Ann Arbor Historic District Commission Staff Report

Address: 217 North Fifth Avenue.

Application Number: HDC26-0042.

Application: The applicant seeks HDC approval to add a basement egress window near the front of the house on the south elevation.

PROPOSED BASEMENT FLOOR PLAN

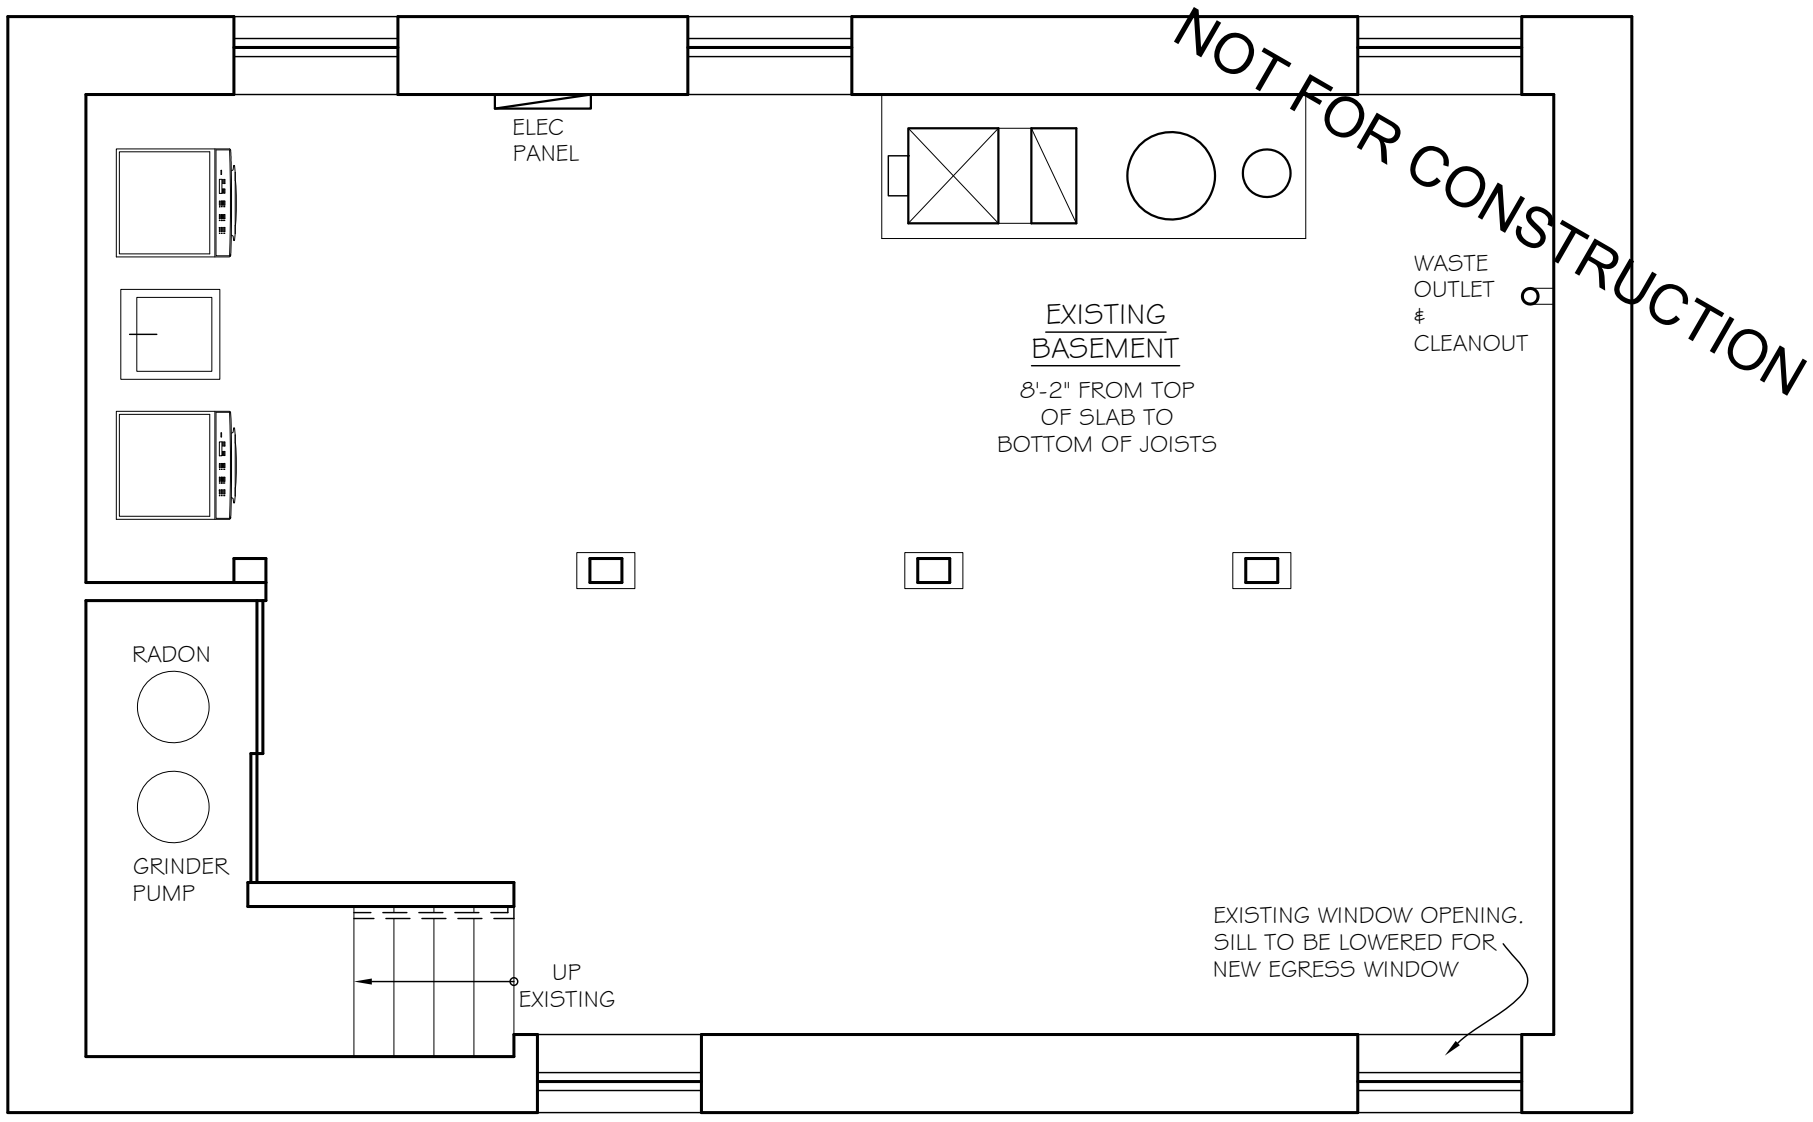
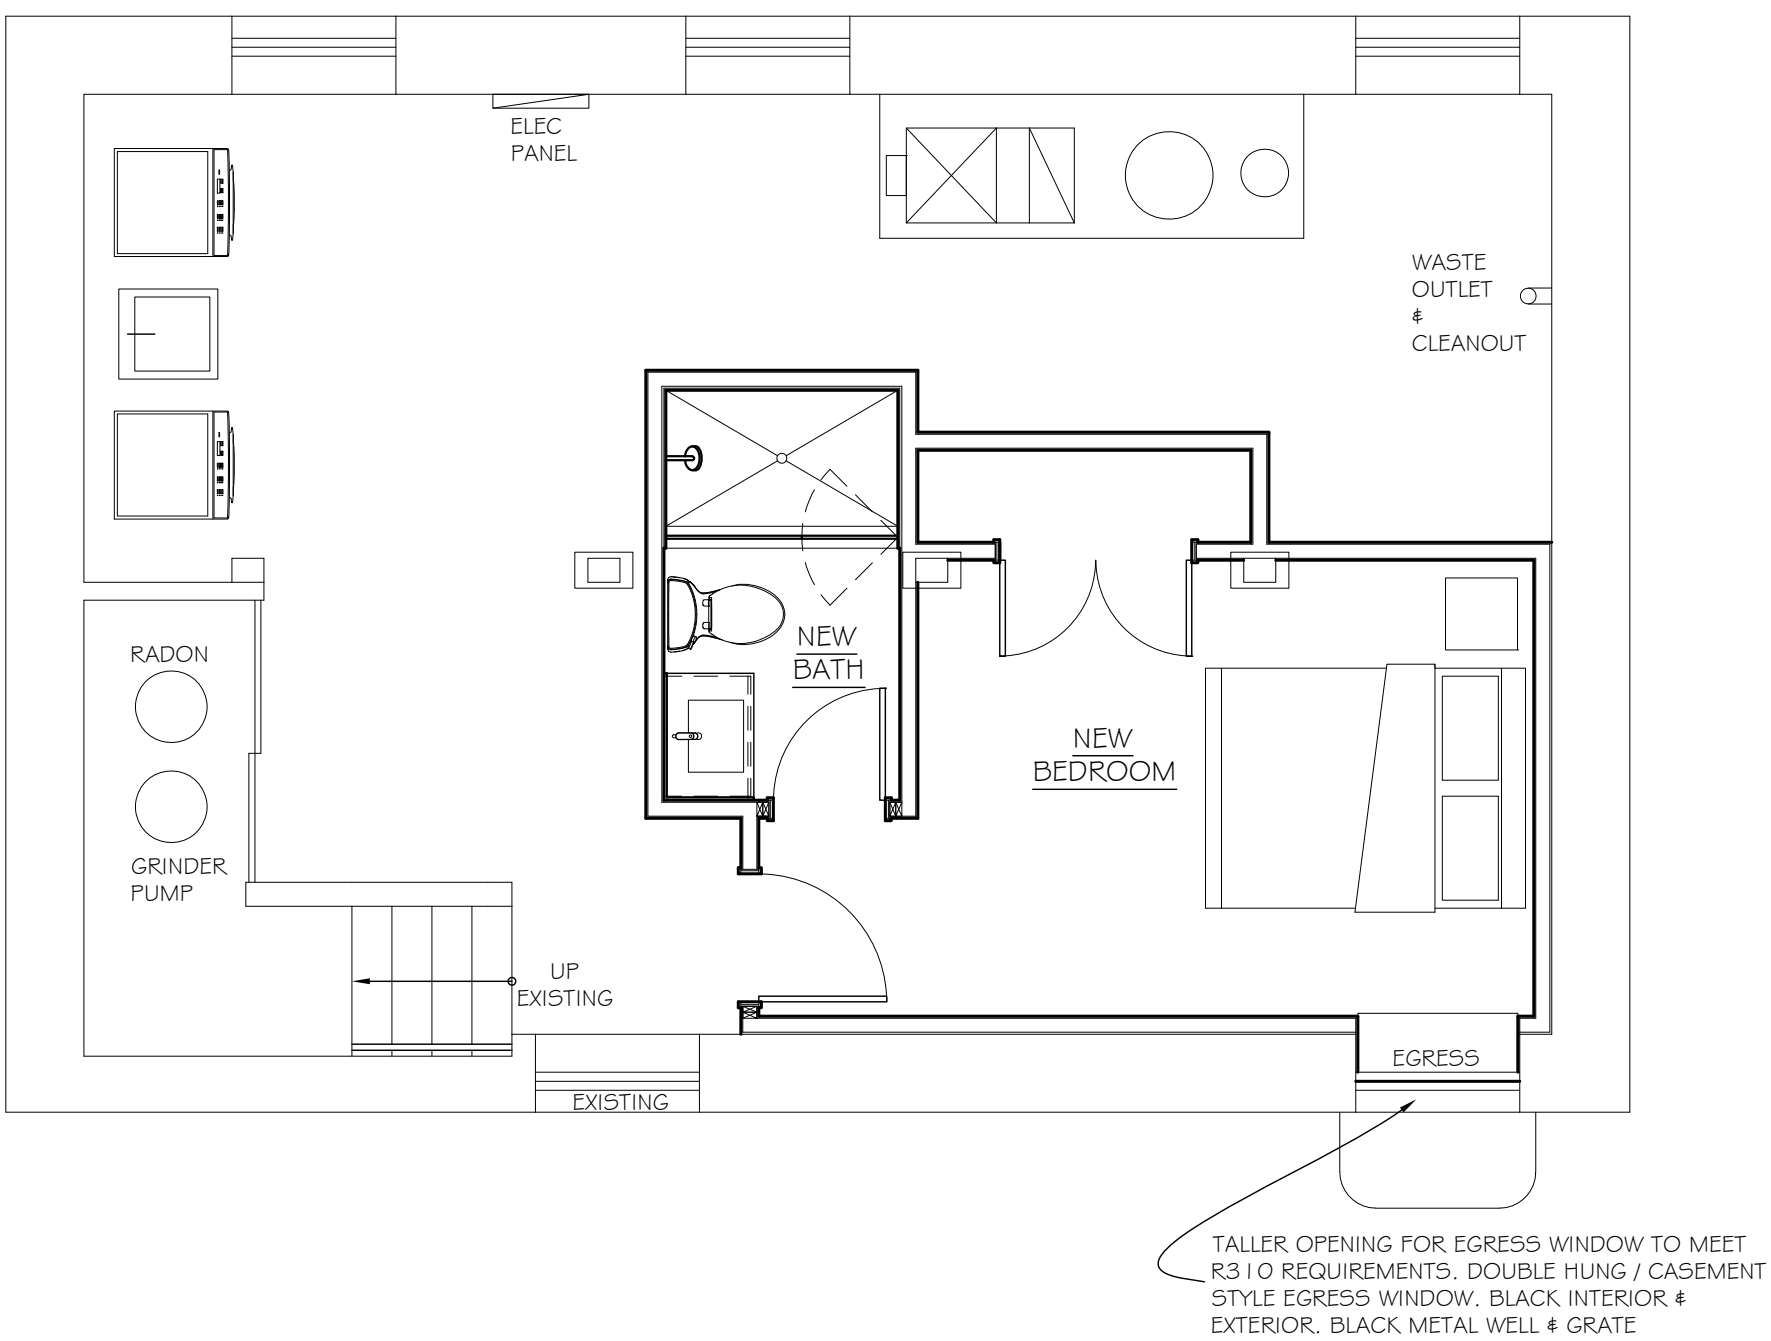
1. The applicant proposes a new egress window well on the south elevation at the front (southeast) corner of the house. It will be an Andersen 100 series Fibrex casement window. There is an existing window opening in this location with the width not specified, but the proposed new window is 29.5” wide and 53 ½” tall. The black metal window well dimensions are not specified; staff has conditioned the motion on the width not exceeding the window opening or 36”, whichever is greater, with a 3 foot horizontal projection from the wall.

3. The applicant originally proposed placing an egress window roughly halfway between the existing south elevation windows, in a new opening. Since this house has a character-defining cut stone foundation, staff recommended that they utilize the existing opening instead of cutting a new opening in the stone above grade. While staff typically recommends denial of basement egress windows this close to the front, because of the circumstances of this particular building, lot, floorplan and historic materials, staff recommends approval of the application. As conditioned, the materials and dimensions are appropriate.

I move that the Commission issue a certificate of appropriateness for the application at 217 North Fifth Street, a contributing property in the Old Fourth Ward Historic District, to construct a new egress window and well on the south elevation near the front of the house, on the following condition: that the width and horizontal depth of the egress well are the minimum required to span the width of the wall opening while meeting code requirements. As conditioned the work is compatible in exterior design, arrangement, texture, material and relationship to the rest of the building and the surrounding area and meets *The Secretary of the Interior's Standards for Rehabilitation* and *Guidelines for Rehabilitating Historic Buildings,* in particular standards 1, 9 and 10 and the guidelines for building site, windows and health and safety, as well as the *Ann Arbor Historic District Design Guidelines* for windows and safety codes.
